**MODIFICATION REQUEST:**  
***Huskisson Hotel***  
***Modification Application No.2***  
***73-75 Owen Street, Huskisson***  
***(Shoalhaven LGA)***  
***(MP07\_0004 Mod 2)***

Director-General's  
Environmental Assessment Report  
Section 75W of the  
*Environmental Planning and Assessment Act 1979*

November 2011

Figure 4: Illustrated plan of proposed MOD2 modifications to the ground floor, illustrating the function room and the proposed mix of outdoor dining / drinking spaces

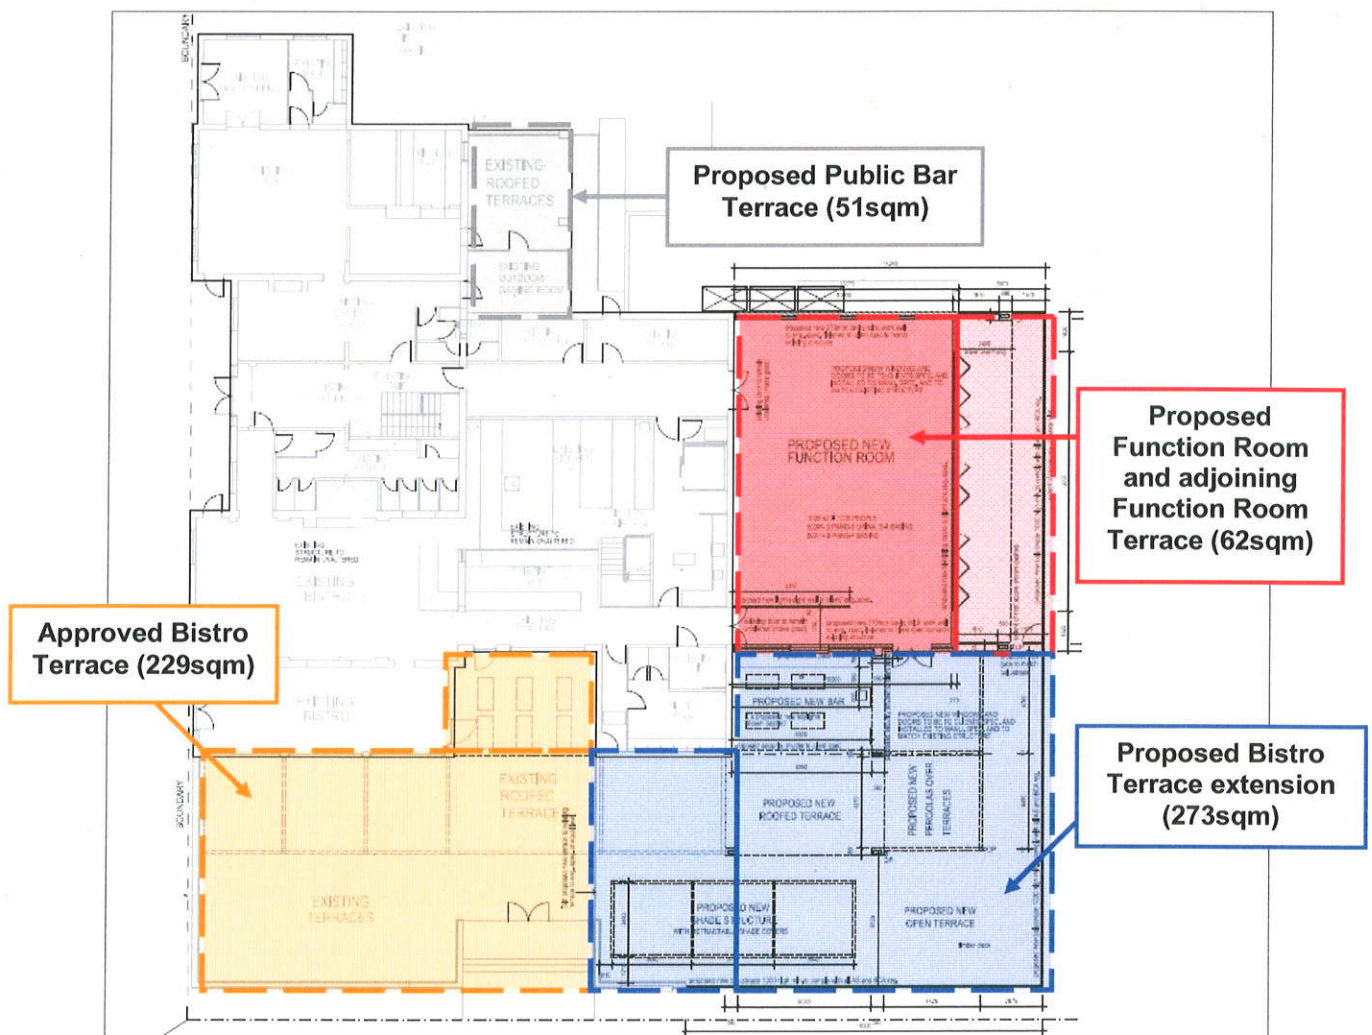
MOD2 proposes the construction and operation of three spaces: a function room with adjacent terrace, a terrace adjacent to the public bar and an extension of the previously approved Bistro Terrace. The proponent states that the terrace next to the Function Room is to be demolished when Stage 3 is constructed.

The MOD 2 amendments propose a number of changes to the size and location of outdoor eating / drinking areas of the Huskisson Hotel. The total of outdoor eating / drinking area proposed for the hotel is approximately 615sqm, comprising of the following four spaces:

2. An *Additional Bistro Terrace* of approximately 273sqm, proposed on the eastern side of the hotel adjoining the proposed Function Room and to the north of the original *Bistro Terrace* area. The combined area proposed for outdoor eating / drinking on the eastern side of the hotel is 502sqm.

3. A (temporary) *Function Room Terrace* of approximately 62sqm, proposed directly to the north of the proposed Function Room. This terrace will be demolished when Stage 2 of approved work is developed.

4. A (temporary) *Public Bar Terrace* of approximately 51sqm, proposed on the western side of the building. This terrace will be demolished when Stage 2 of approved work is developed.

In its submission, the Council notes that the size of the existing beer garden is 354sqm and that this space has been demolished in preparation for Stage 1 work. Shoalhaven Council has no objections to the proposed increase in the size of

outdoor eating / drinking areas for the Huskisson Hotel and supports the additional Bistro Terrace, Public Bar Terrace and the Function Room Terrace.

The Department is of the opinion that the proposed mix of outdoor eating / drinking spaces proposed by MOD2 will benefit and improve the function / operation, flexibility and design of outdoor space of the Huskisson Hotel. The noise and amenity impacts of the proposed outdoor eating / drinking spaces are considered to be consistent with that of hotel's existing beer garden.

1. the maximum size of the hotel's Stage 1 outdoor eating / drinking areas should be limited to 615sqm, that reflect the MOD2 proposals and plans for Stage 1 of the project;
2. at the completion of Stage 2, the hotel's outdoor eating / drinking area be limited to 502sqm; and
3. upon the completion of the 3<sup>rd</sup> and final stage of the project, the outdoor eating / drinking areas be limited to the 229sqm Bistro Terrace, located in the south eastern corner of the site, as illustrated and defined in the original project approval.
